MEMORANDUM

TITLE:PUBLIC HEARING regarding Board Approval and Site Plan for the
McRady RV Storage Facility, located on Tract 1, McRady Subdivision,
Situated in Section 8, T13N, R66W, of the 6th P.M., Laramie County, WY.

McRady RV Storage

Outlet Structure Detail:

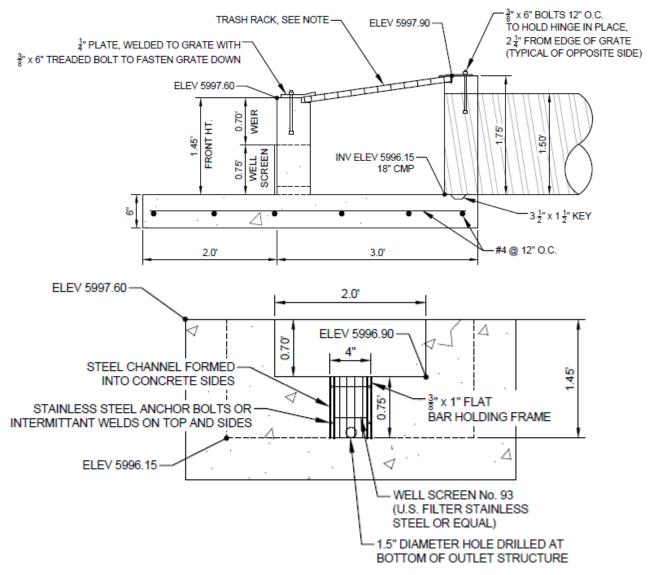
15.Upon completion of the site, an engineer or land surveyor shall submit a certification letter to the County certifying the as-constructed conditions for the grading, drainage, detention pond, outlet structure, etc. meet the approved plans and indicate what the post construction detention pond volume is compared to the volume requirements in the Drainage Study. 16.Please verify that the outlet end of the existing 36 culvert that crosses Avenue C is not blocked, silted in, etc.; it is difficult to tell on the street view on google. That pipe needs to be completely open to allow for the discharge from the detention pond to be able to flow through it. 17.Please verify that the flow coming out of the detention

pond is capable of passing through the sidewalk chase, so

the sidewalk isnt always being overtopped and flooded.	
04/12/2024	board appro	Application e completed val completed een recorded	PZ-24-00039	GENERAL	 change. Do not remember a zone change request. Cannot approve the site plan without a zone change. 714 E. College already has a building, possibly a house on the lot. Much of 714 and 716 of E. College Drive seem to be use as a residence and vehicle storage. Is there a plan to split these two lots in half? Is there a plan to vacate the 	LARAMIECOUNTY ATTORNEY@LARA MIECOUNTYWY.G OV
04/15/2024	1. ack 2. ack	Norkflow	WYDOT REVIEW	GENERAL	0 0 ,	@LARAMIECOUNT YWY.GOV

The outlet structure is detailed on sheet 5 of the construction plan set, and shown on the following page. The outlet structure consists of a concrete box with the previously described 1.5" hole at the bottom, a weir near the top of the box, and a trash rack on top of the open box. An 18" CMP outlet pipe controls water releasing from the pond. Storm water released from the pond is then directed to the existing 36" culvert under Avenue C.
